**Economic and Social Council**Distr.: General  
18 November 2014

**Economic Commission for Europe****Inland Transport Committee****World Forum for Harmonization of Vehicle Regulations****Working Party on Noise****Sixty-first session**

**Regulation No. 51 (Noise of M and N categories of vehicles): Development****Proposal for amendments to the 03 series of amendments to Regulation No. 51****Submitted by the Informal Working Group on UN Regulations Nos. 51 and 59<sup>1</sup>**

Figure 3a [Flowchart for vehicles tested according to 3.1.2.1. –  $L_{urban}$  computation]

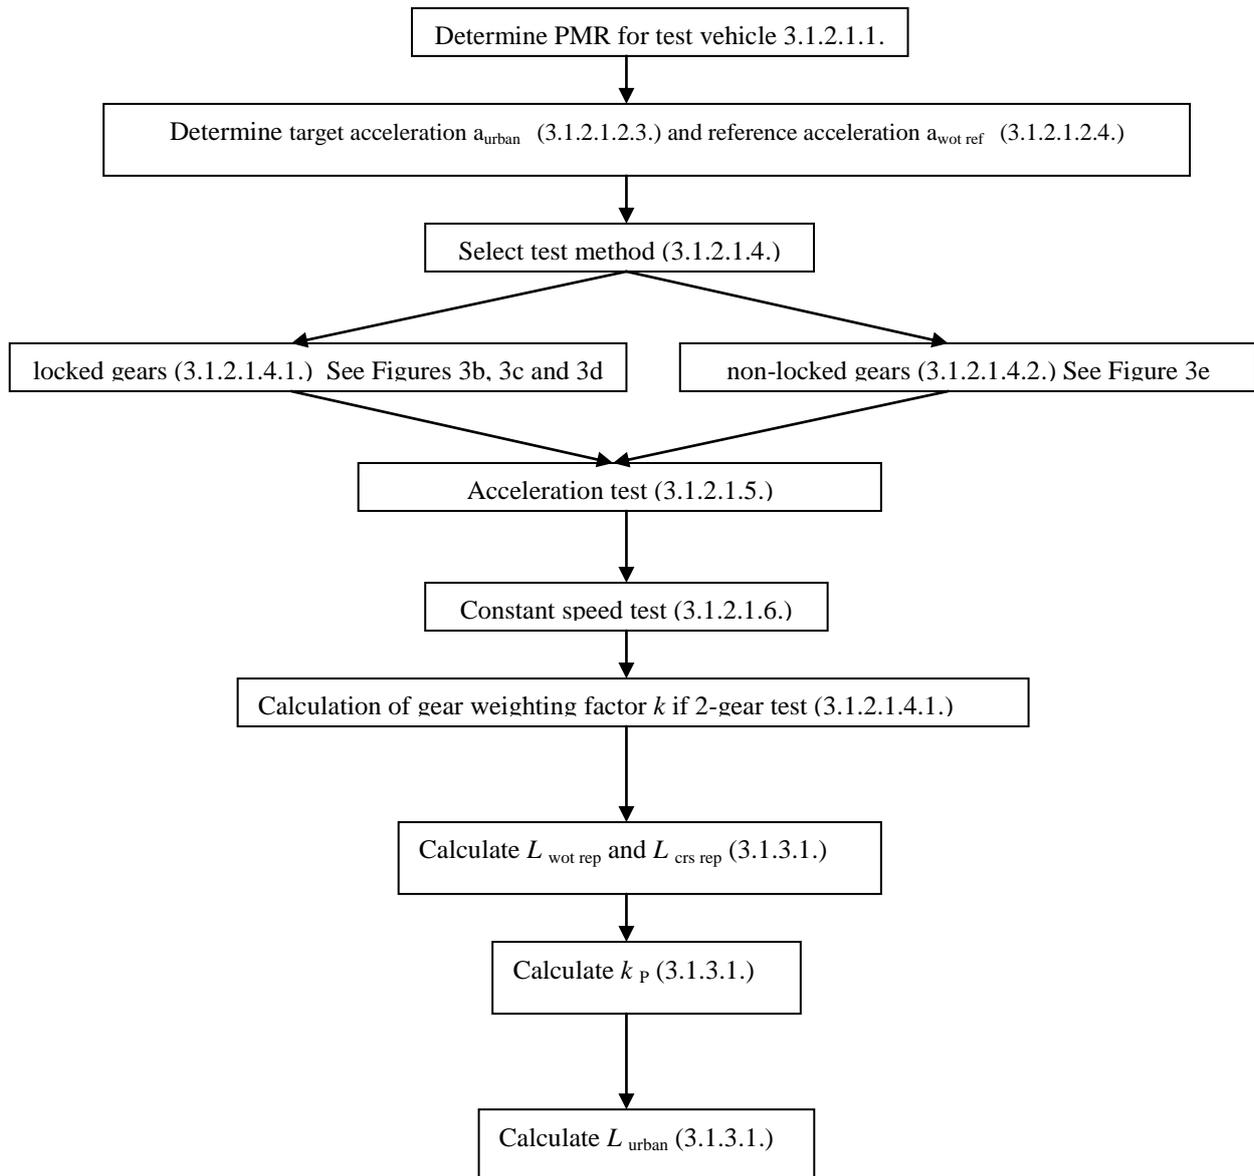
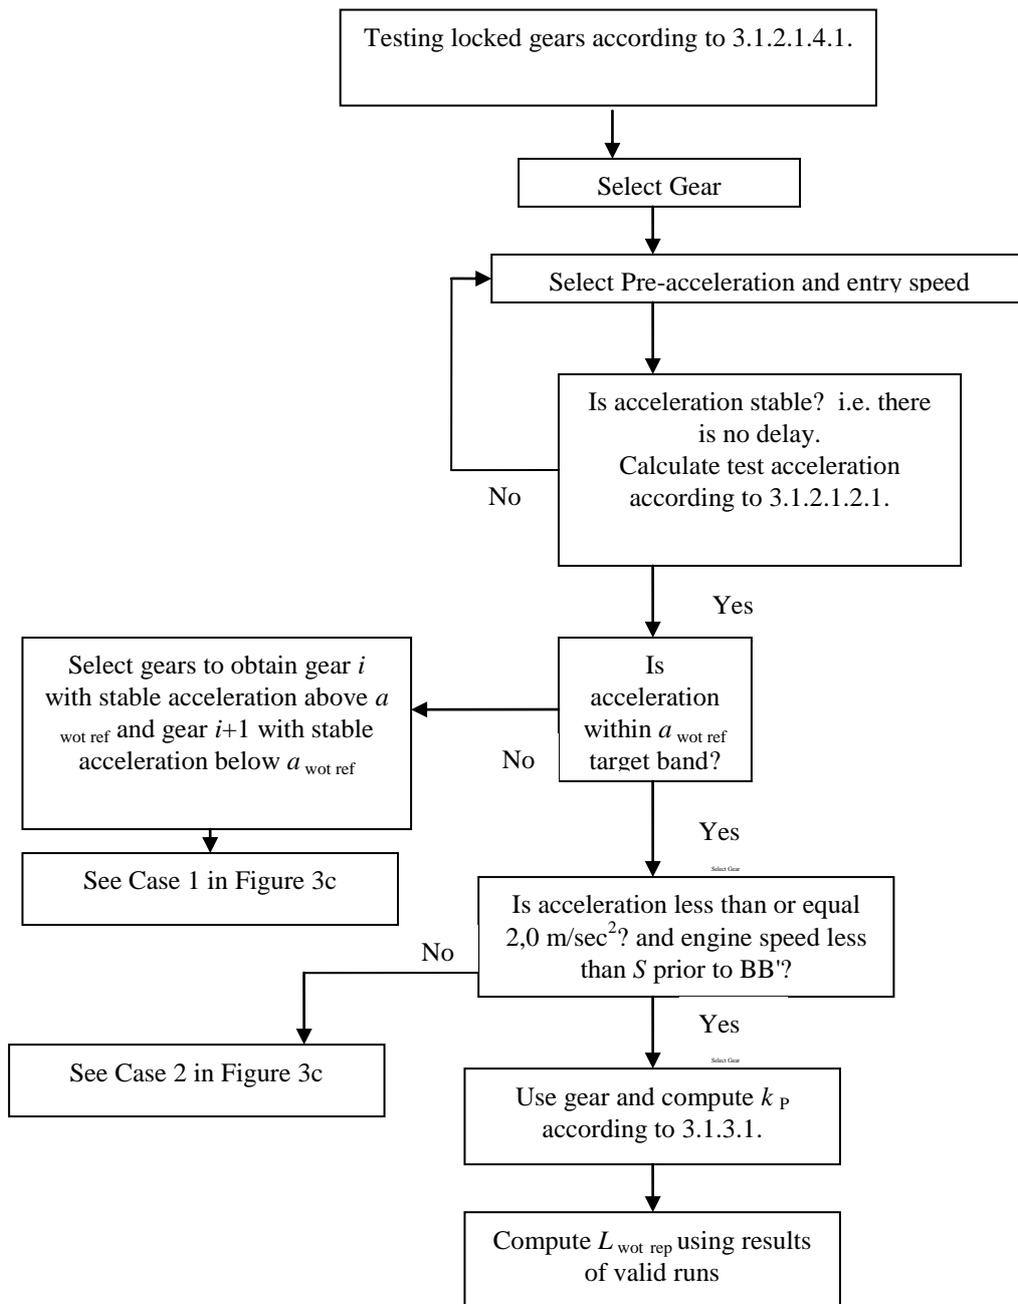
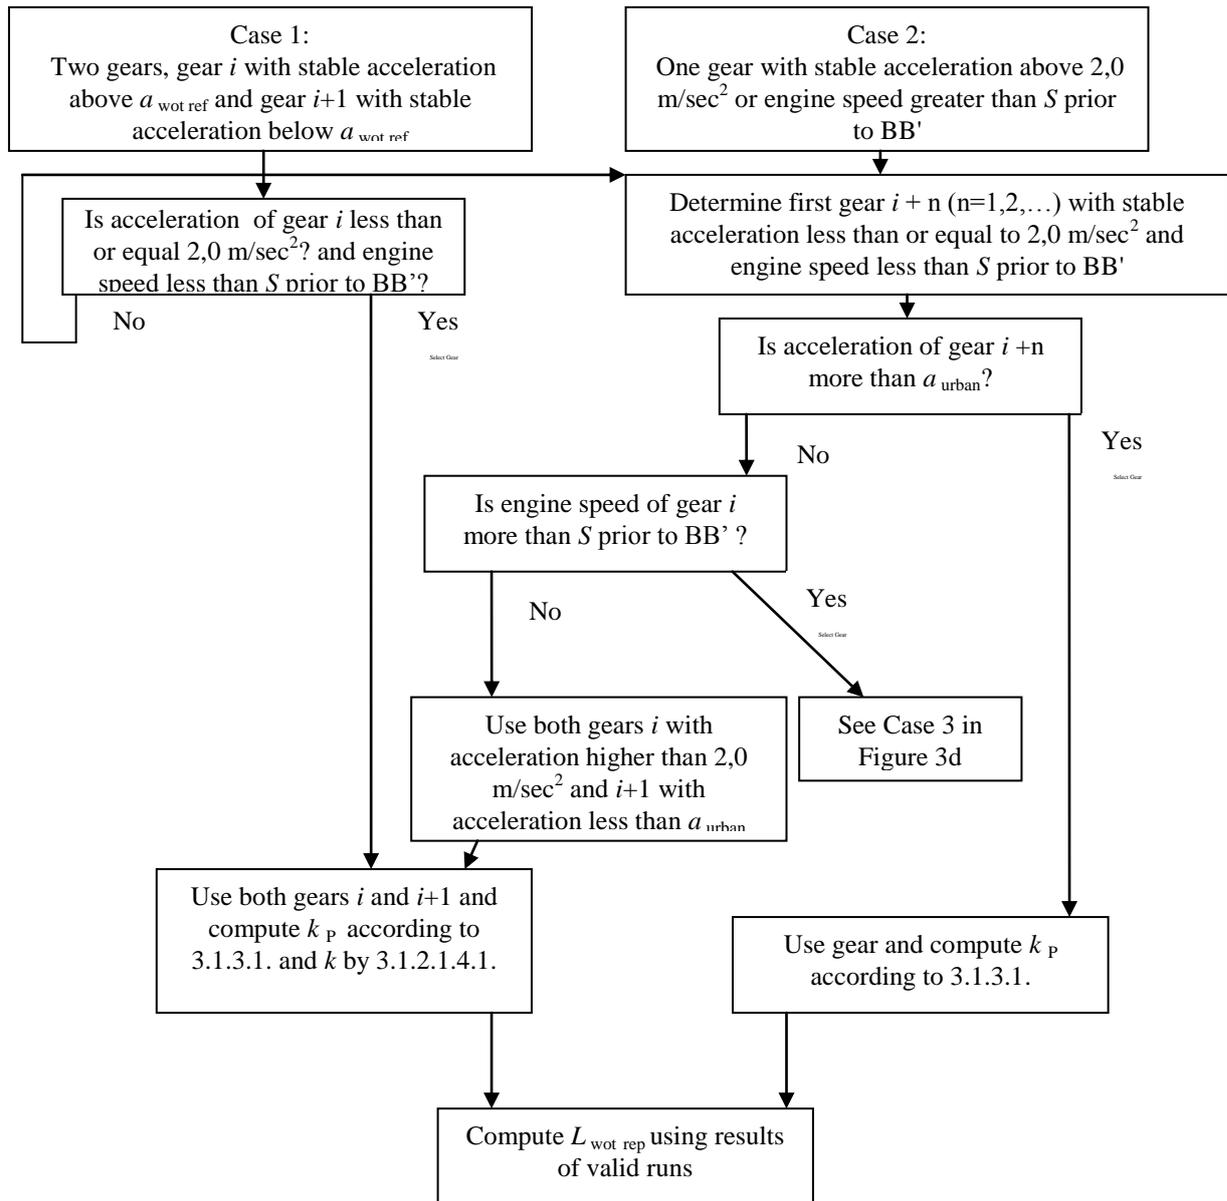
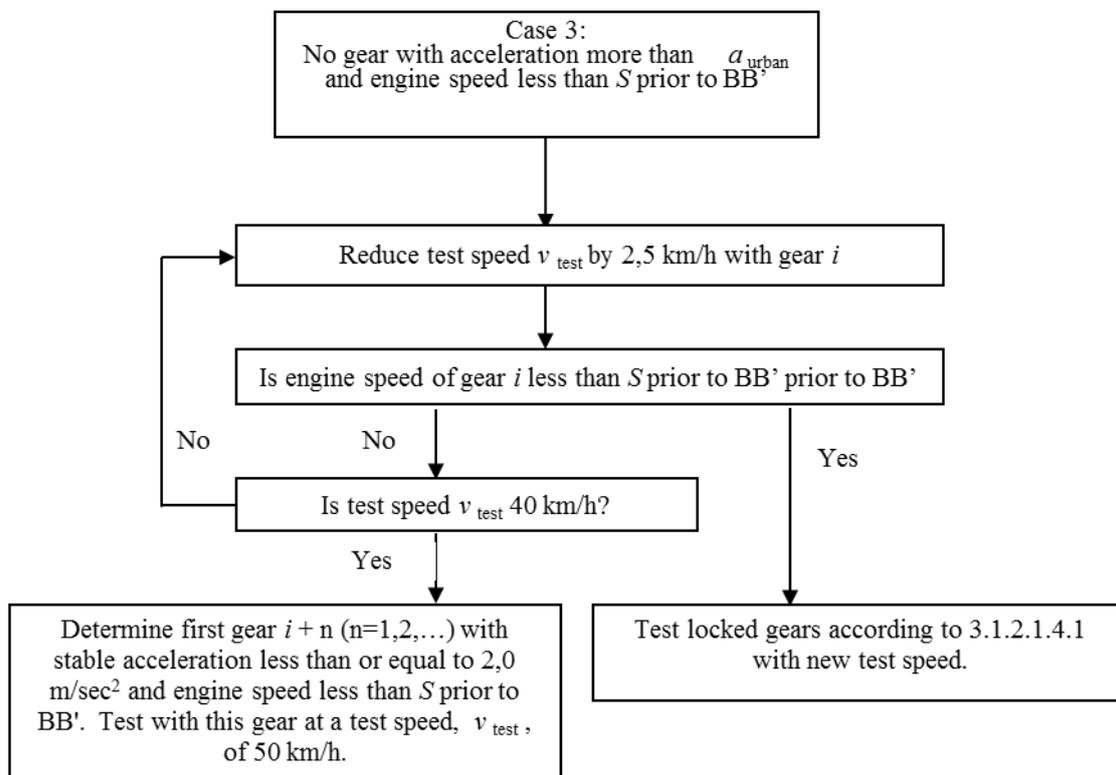
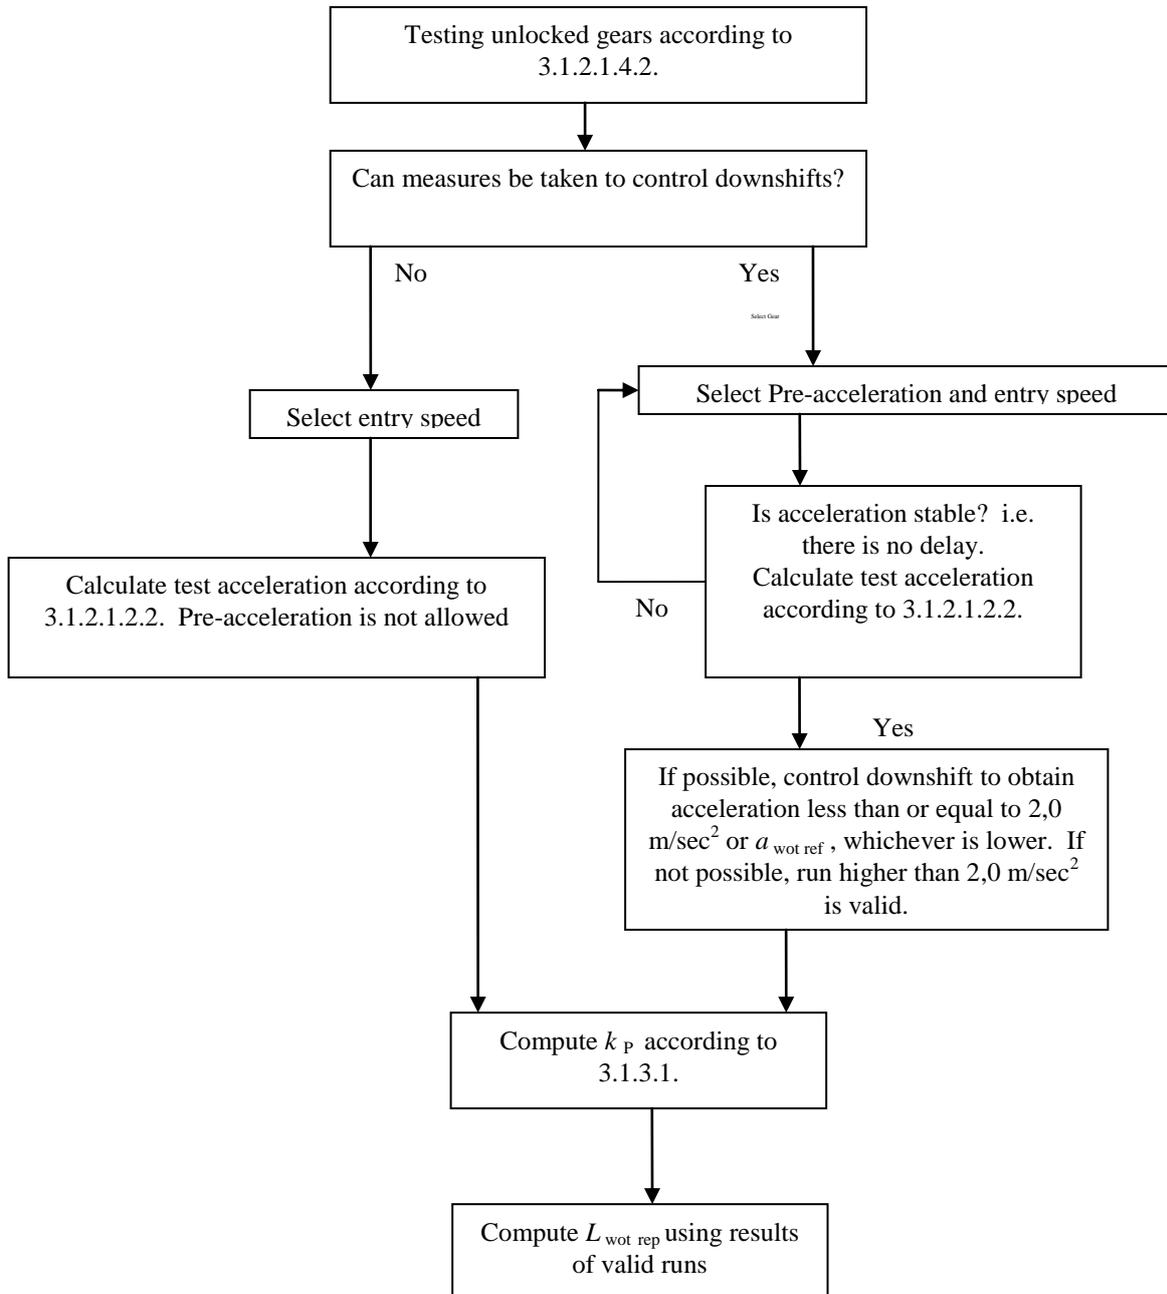
**Appendix 3, Figure 3a to Figure 3e, give gear selection criteria and test run criteria for categories  $M_1$  and  $M_2$  having a technically permissible maximum laden mass not exceeding 3.500 kg and for category  $N_1$ , in a flowchart form as an aid to test operation.”**

*Annex 3, Appendix 3, amend to read:*

29. The flowcharts have been added to assist test engineers in the correct selection of test modes and the calculation of test results for the pass-by tests of Annex 3.

Figure 4a [Flowchart for vehicles tested according to 3.1.2.2. – Test in locked gears]

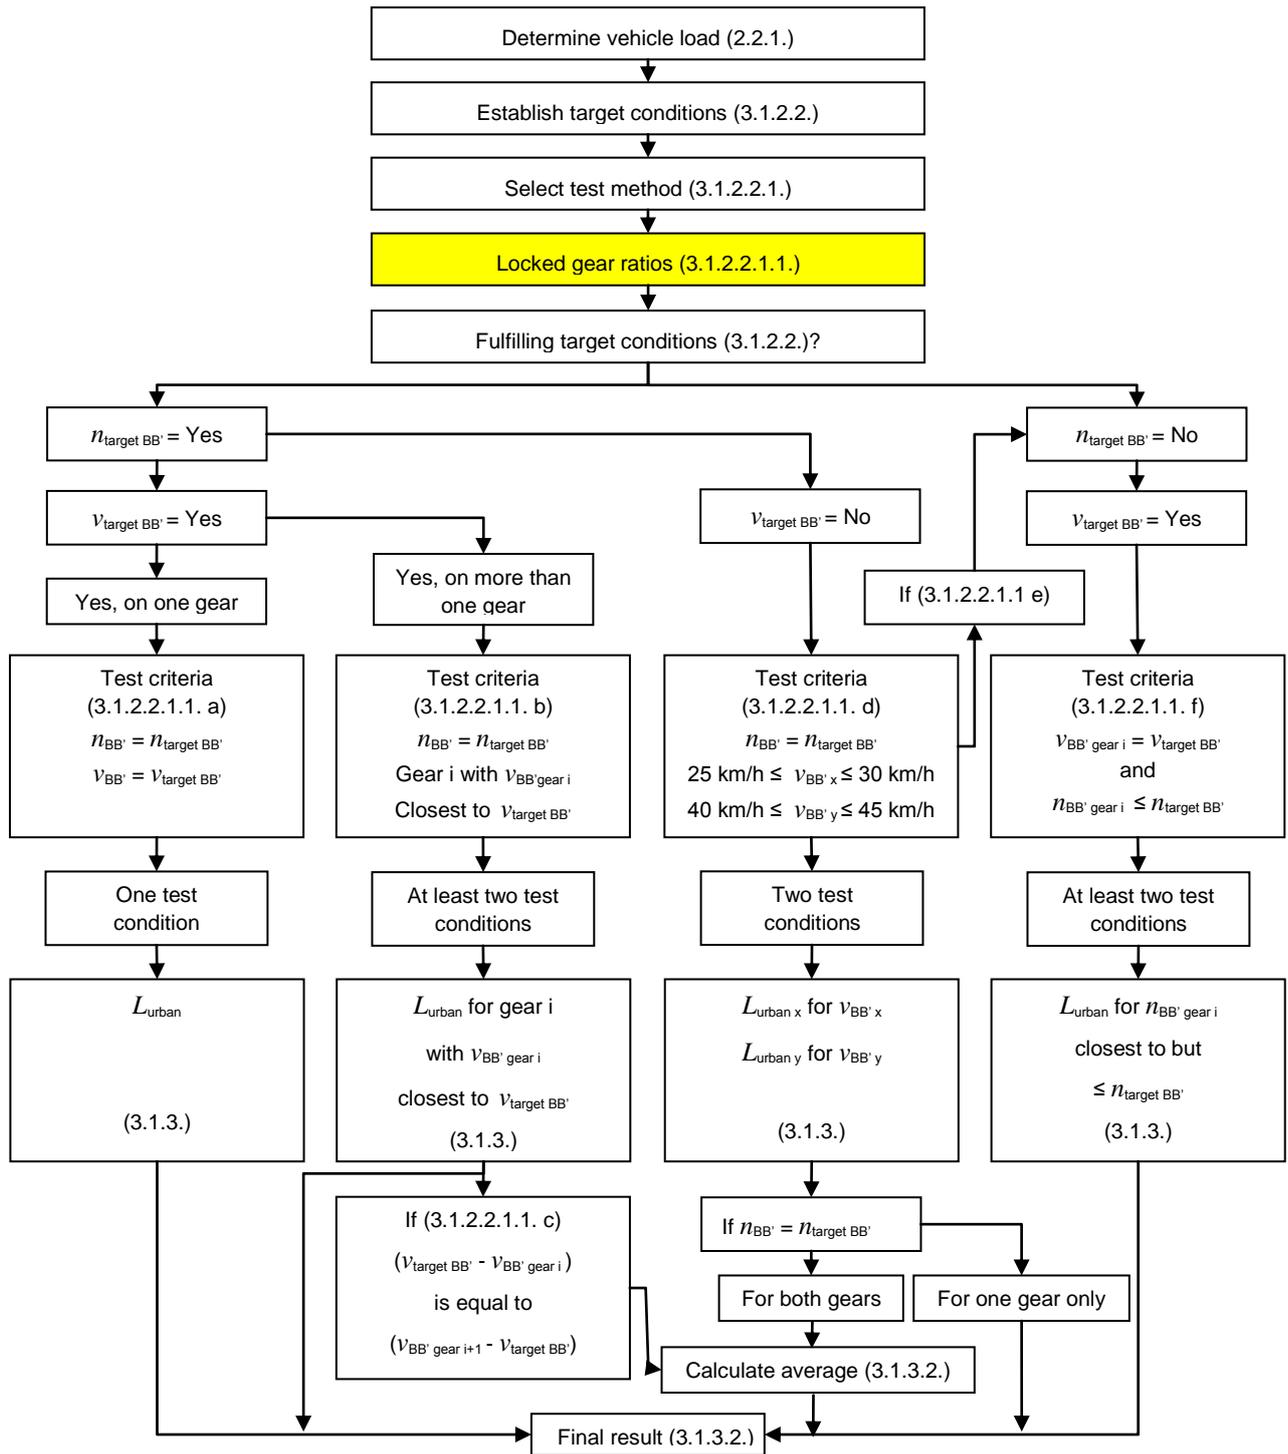
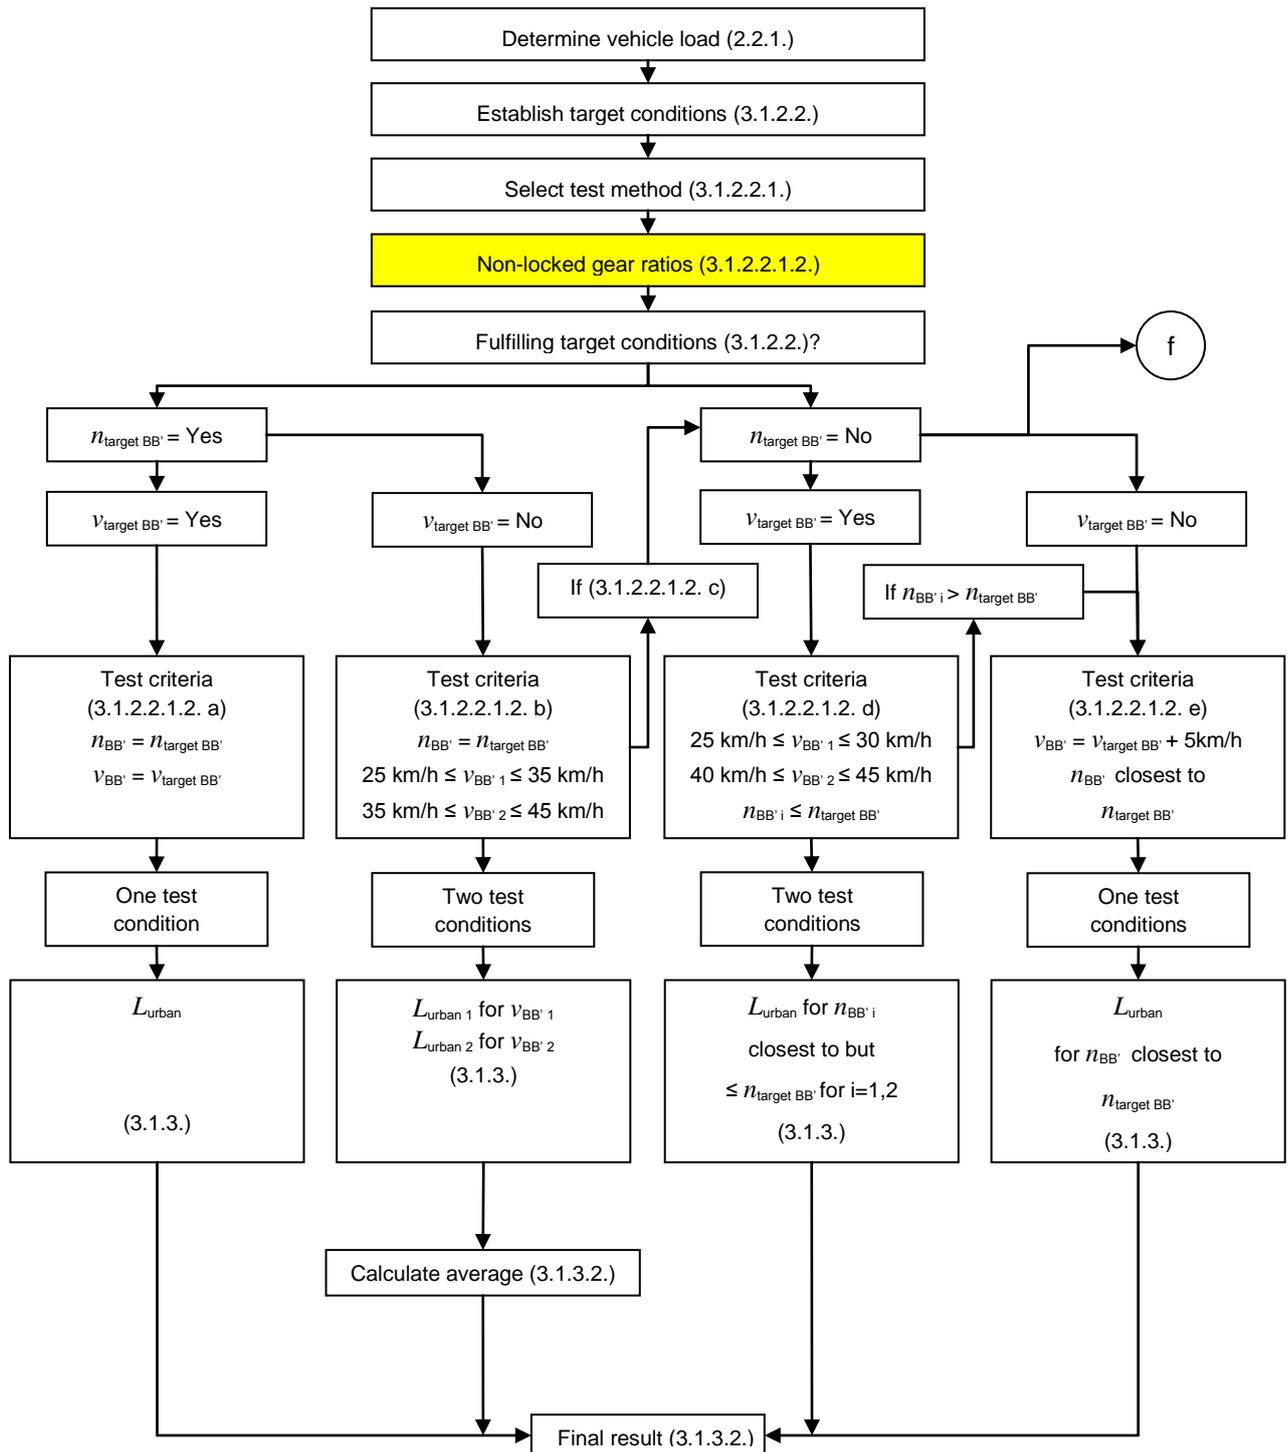
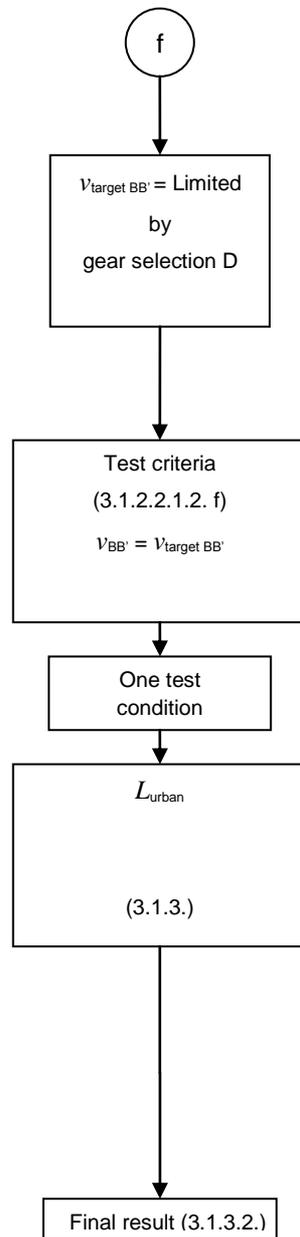
**Appendix 3, Figure 4a to Figure 4d, give gear selection criteria and test run criteria for categories M<sub>2</sub> having a technically permissible maximum laden mass exceeding 3,500 kg, and for category N<sub>2</sub>, M<sub>3</sub> and N<sub>3</sub>, in a flowchart as an aid to test operation.”**

24. After the introduction of the flowcharts (Figure 4a to 4d) in Annex 3 Appendix 3 for vehicles of categories  $M_2$  having a technically permissible maximum laden mass exceeding 3,500 kg, and for category  $N_2$ ,  $M_3$  and  $N_3$ , there is a need to connect them to the right paragraph in Annex 3.
